**PRELIMINARY
ENVIRONMENTAL NOISE REPORT
AND
LAND USE COMPATIBILITY REPORT**

PROPOSED INDUSTRIAL DEVELOPMENT
772 WINSTON CHURCHILL BOULEVARD
TOWN OF OAKVILLE

Revised December 13, 2022
Revised December 15, 2021
June 25, 2021
File: 21-051-01

This revised report considers peer review comments provided by Dillon Consulting Limited (on behalf of the Region of Halton) dated April 18, 2022 regarding our December 15, 2021

FIGURE 6

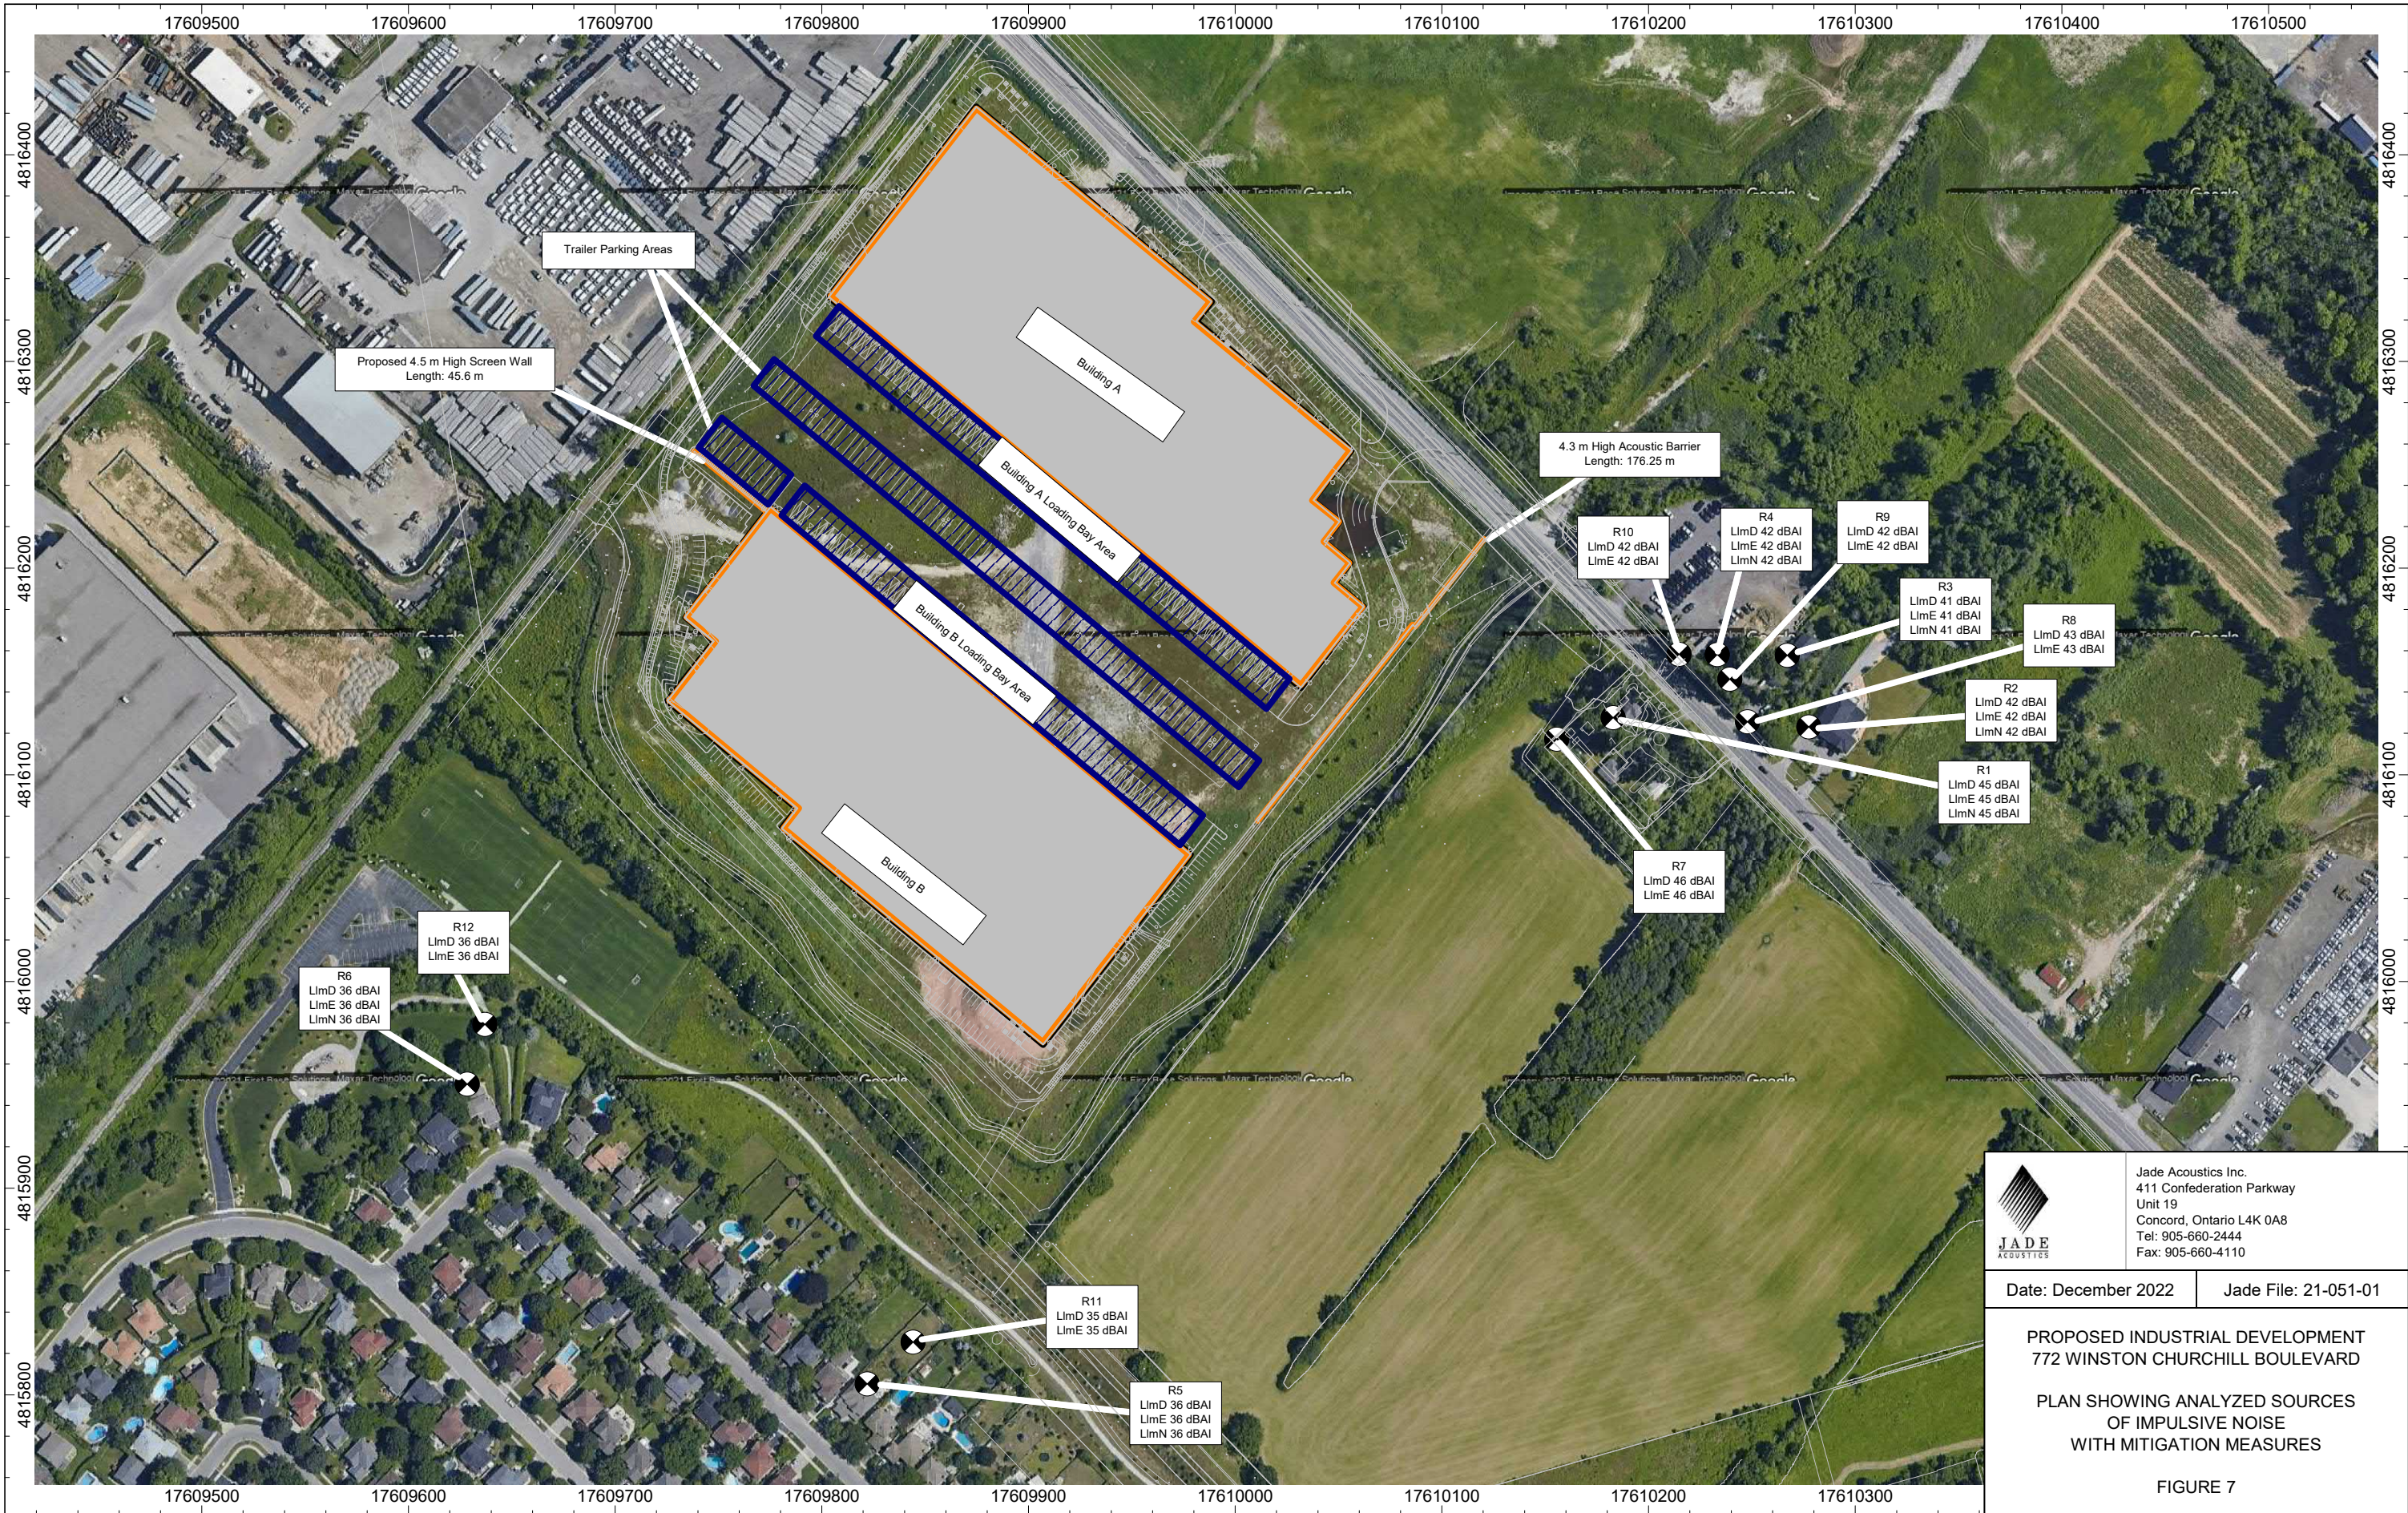
The proposed acoustic barrier shown on Figures 6 to 8 is needed to address the existing residential receptors to the southeast of the subject site (Receptors R1 to R4 and R7 to R10). It should be noted that this acoustic barrier is not required to meet the applicable sound level limits at the existing residential development to the west/southwest. As shown on Figures 3 to 5; the proposed 4.5 m high screen wall on the north side of Building B and the building locations and orientation provide sufficient screening to achieve the applicable sound level limits. It should be noted that the 4.5 m high screen wall is required to achieve the sound level limits at the receptor locations and should not be removed or reduced in height or length once constructed.

The design detail considerations such as, but not limited to, grading and structural implications will need to be confirmed by the appropriate technical discipline prior to implementation. The sound barrier height is to be measured from the proposed finished grade on the northwest side of the fence line (location shown on Figures 6 to 8), as there is a grade change needed to accommodate drainage at this location.
